UNITED STATES PATENT AND TRADEMARK OFFICE

Office Action Summary

10/733,213

DETAILED ACTION

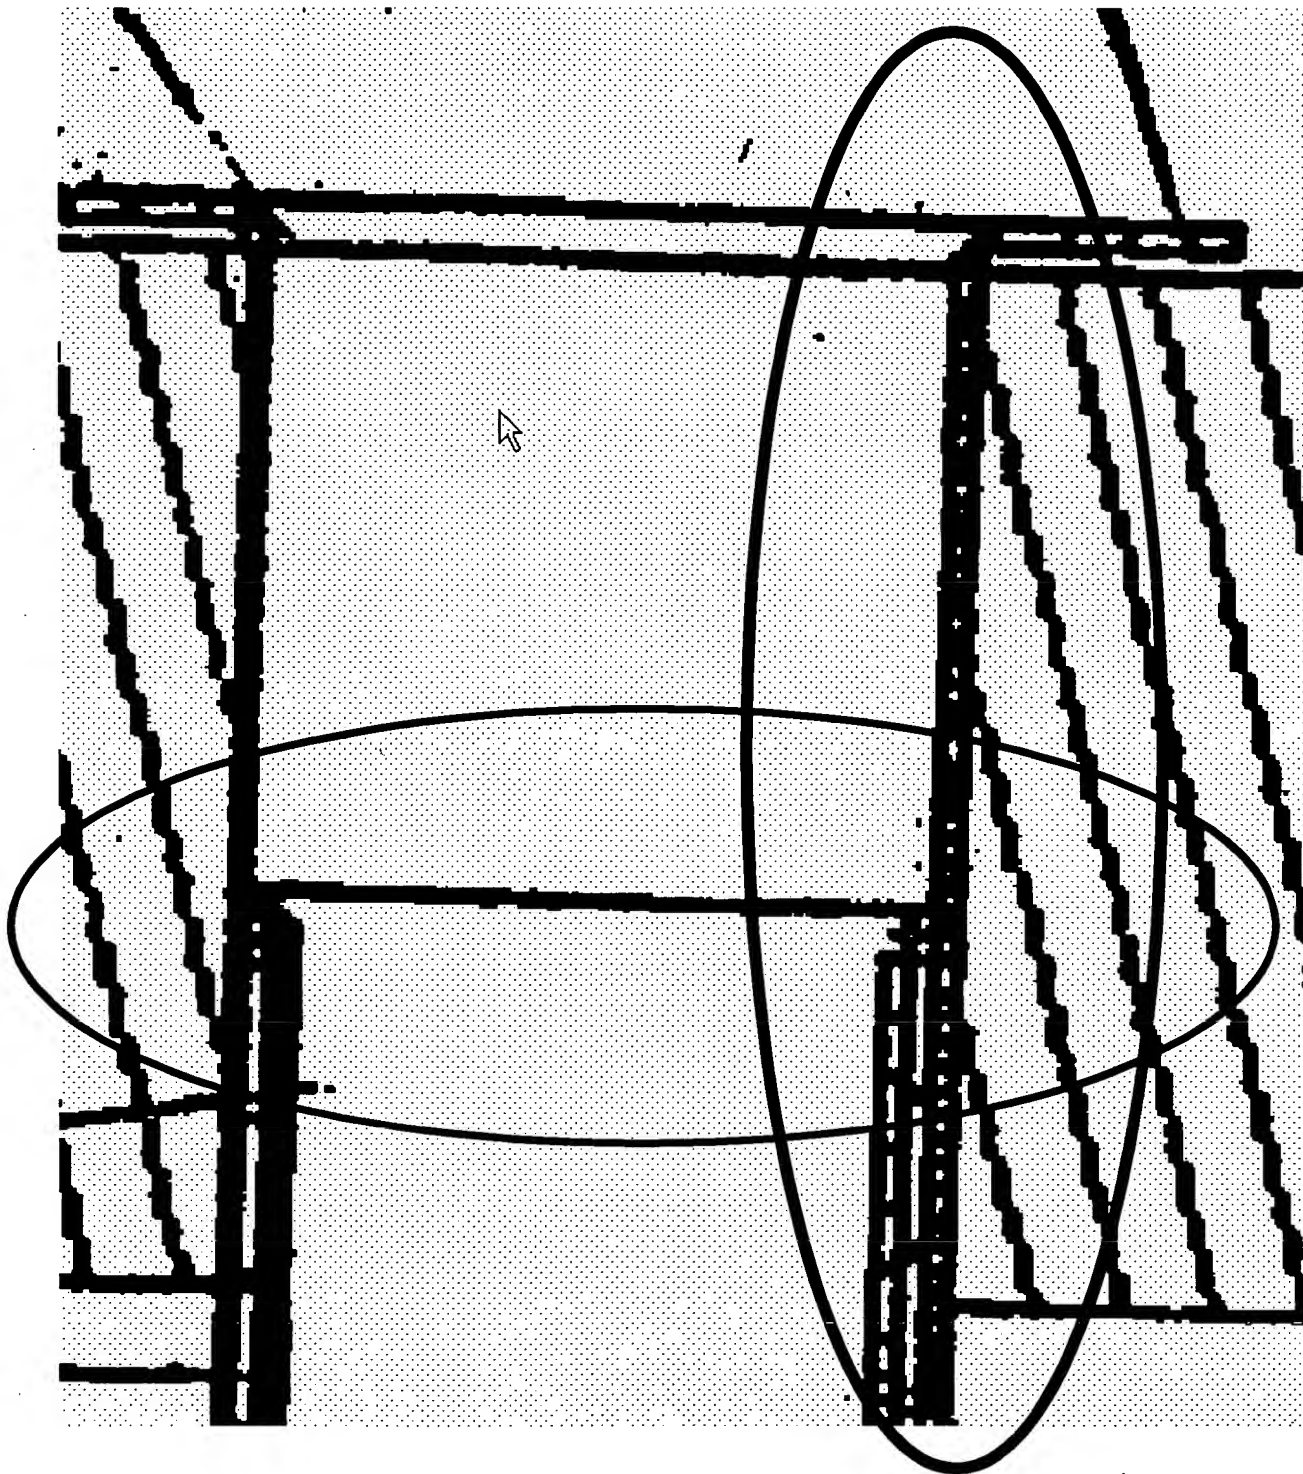
2. **The drawings are objected to under 37 CFR 1.83(a) because they fail to show the repair sleeve having a lapped edge as described in the specification as**

filed, page 5 lines 22+. As illustrated in the exploded portion of Figure 2 below, Figure 2 does NOT indicate that shaft 72 continues past the horizontal line encompassed by the horizontal oval below. Figure 2 appears to show that it is actually guide thimble sleeve (68) that is lapped over the edge.

Any structural detail that is essential for a proper understanding of the disclosed invention should be shown in the drawing. MPEP § 608.02(d). Corrected drawing
